Work Order ID 101163

Item Name: Crosstube Turning Detail

DART AEROSPACE LTD		Work Order: 101163
Description: Crosstube Assembly (205/212/412 High Fwd)		Part Number: D212-664-141
Inspection Dwg: D212-664-141 Rev: D		Page 1 of 2

DRAWING NO. D212-664-141	TITLE XTUBE ASSY (205/212/412 HI FWD)	REV. D	DART AEROSPACE LTD ENGINEERING ORDER		D.E.O. NO. D212-664-141-D-1	SHEET NO. SHEET 1 OF 2	SCALE NT3
DRAWN	CHECKED	OP	MFG. APPR.	APPROVED	DE APPR.		
DATE 11.04.07	DATE 11.04.11		DATE 11.04.12	DATE 11/04/12	DATE 11.04.12

**D212-664-141/-141B
ASSEMBLY DETAIL**

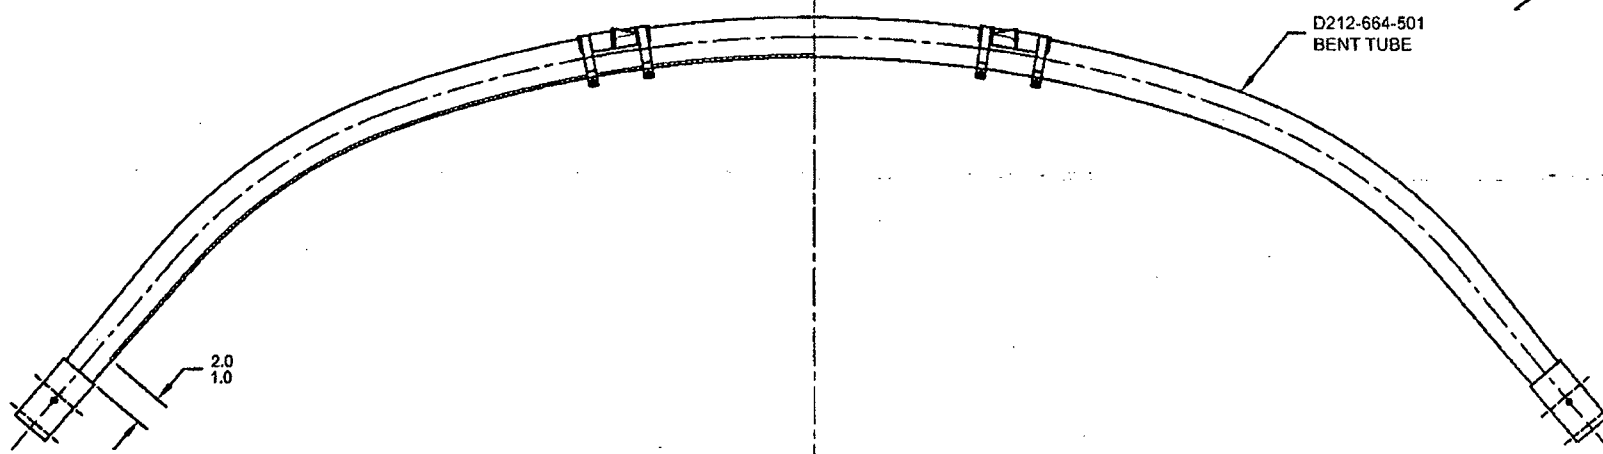
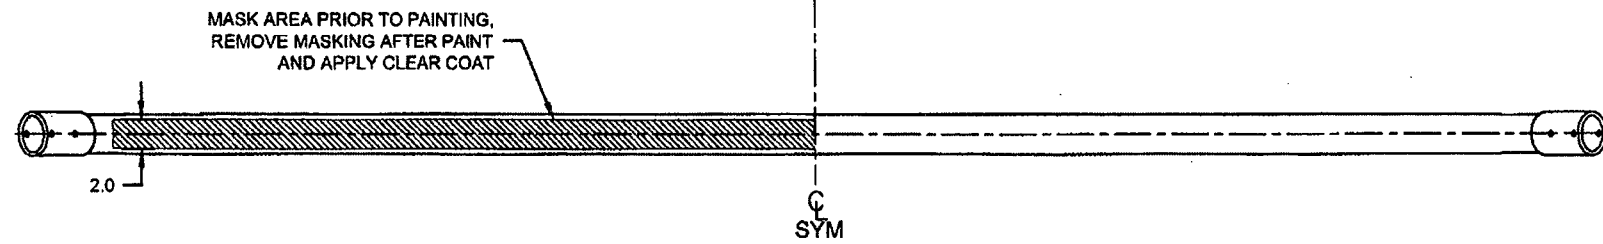
PURPOSE:

ADD AN INSPECTION WINDOW TO UNDERSIDE OF CROSSTUBE.

NOTES 2 OF SHEET 1 IS AMENDED AS FOLLOWS:

IS:

- 2) FINISH: CHEMICAL CONVERSION COAT PER DART QSI 005 4.1
PRIME INSIDE AND OUTSIDE PER DART QSI 005 4.2
MASK UNDERSIDE OF CROSSTUBE AS SHOWN (HATCHED AREA) AND
PAINT OUTSIDE PER DART QSI 005 4.2
REMOVE MASKING AND APPLY CLEAR COAT

WAS:

- 2) FINISH: CHEMICAL CONVERSION COAT PER DART QSI 005 4.1
PRIME INSIDE AND OUTSIDE PER DART QSI 005 4.2
PAINT OUTSIDE PER DART QSI 005 4.2
